Proposal #33: 1580-04-74, WISC 2023168
Ladysmith - Prentice
East 16th St. N./Old 8 Road to
Price County Line
USH 8
Rusk County

This is Addendum No. 01, which provides for the following:

ADDENDUM NO. 01

1580-04-74

Addendum No. 01
 ID 1580-04-74
 Revised Sheet 39
 December 20, 2022

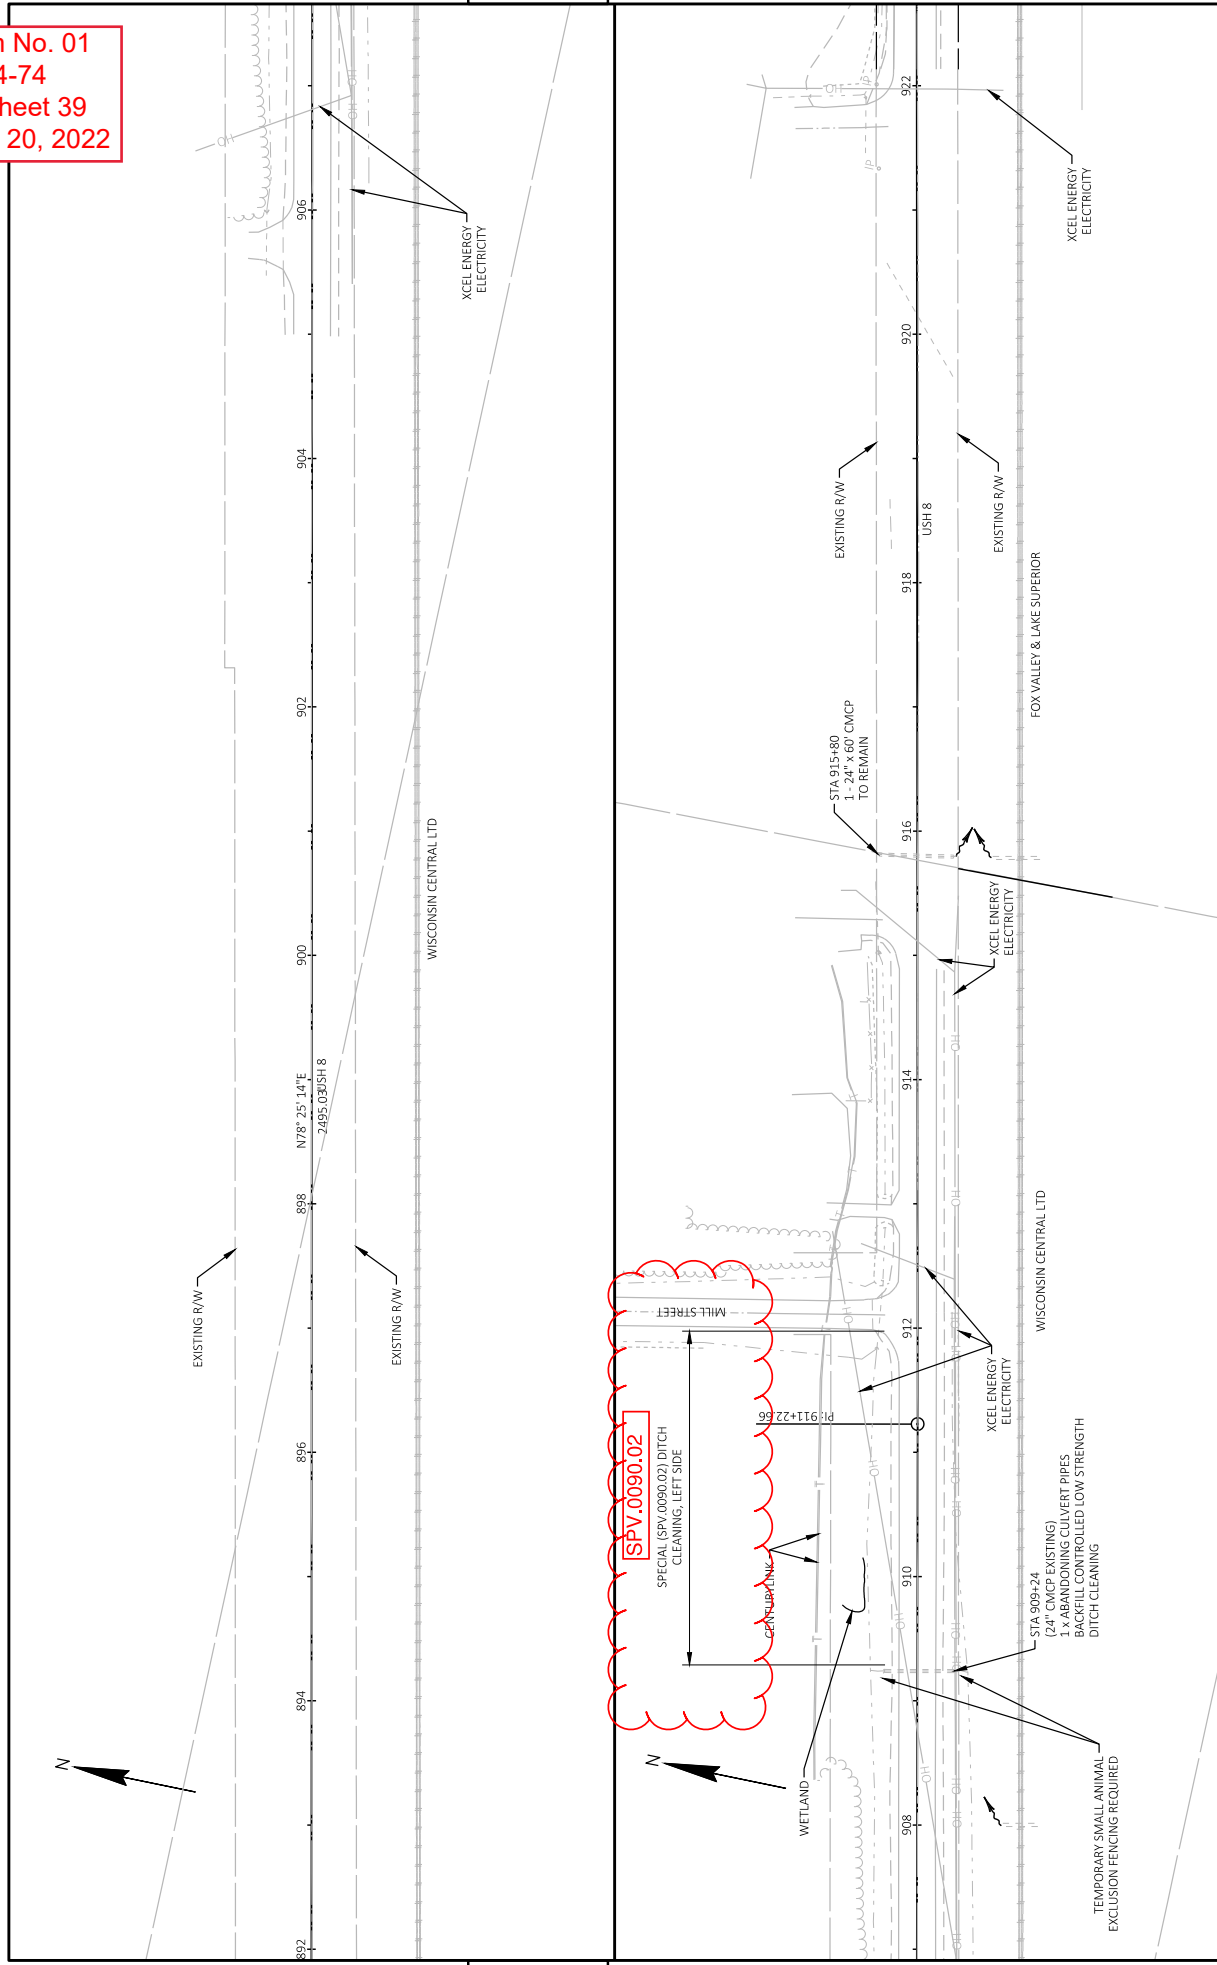
Revised Plan Sheets	
Plan Sheet	Plan Sheet Title (brief description of changes to sheet)
39	Plan Sheet (bid item number changed)
